Access Compliance Report Public Rights-of-Way (Curb Ramps)

Main Street: CHARDONNAY_DR		Cross Street: ROANOKE_DR		Location:	SW
ADA ID: RPRK211115113423	Ramp Type: Type 4 - Parallel	Initial Pass/Fail: Fail	Overall Compliance: No	Severity Score:	15
Codes/Mitigation Info/Possible Solution			Field Measurements/Component Compliance

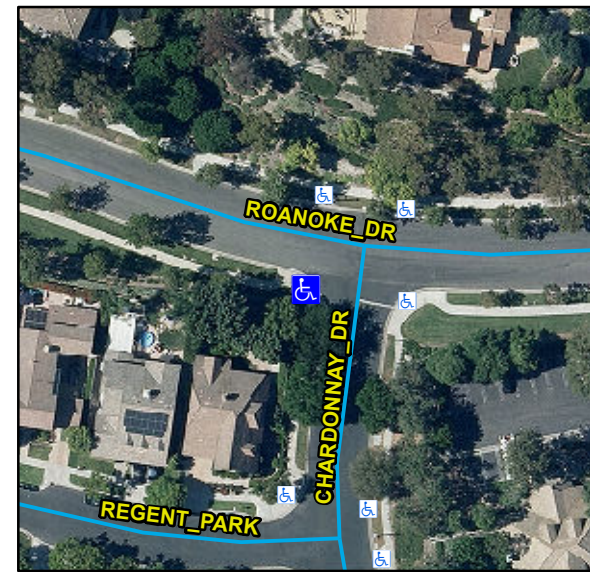
R204.3, R304.3.2, STD 1115

Compliance	Description	Data	Compliance	Description	Data
N/A	Ramp Length LT (in)	129	N/A	Ramp Length RT (in)	134
Yes	Ramp Width LT (in)	95	Yes	Ramp Width RT (in)	95
No	Ramp Run Slope LT (%)	11	Yes	Ramp Run Slope RT (%)	0.3
Yes	Ramp Cross Slope LT (%)	0.7	Yes	Ramp Cross Slope RT (%)	1.6
N/A	Landing Present	N/A	N/A	DWS Provided	N/A
N/A	Landing Length (in)	N/A	N/A	DWS Contrast	N/A
N/A	Landing Width (in)	N/A	N/A	DWS Length (in)	N/A
N/A	Landing Run Slope (%)	N/A	N/A	DWS Full Width	N/A
N/A	Landing Cross Slope (%)	N/A		DWS Offset Type	N/A
N/A	Landing Movement Obstructed?	N/A	N/A	DWS Offset Left (in)	N/A
	Landing Movement Type	N/A	N/A	DWS Offset Right (in)	N/A
N/A	Landing Shared	N/A			
N/A	Clear Space	Yes			
N/A	Clear Space To Crosswalk (in)	N/A			
N/A	Marked Crosswalk 1	No	N/A	Marked Crosswalk 2	No
	Crossing 1 Direction	SE		Crossing 2 Direction	NE
N/A	Marked Crosswalk 1 Width (in)	N/A		Marked Crosswalk 2 Width (in)	N/A

Remove & Replace Curb Ramp With Two New Directional Ramps or Equivalent.
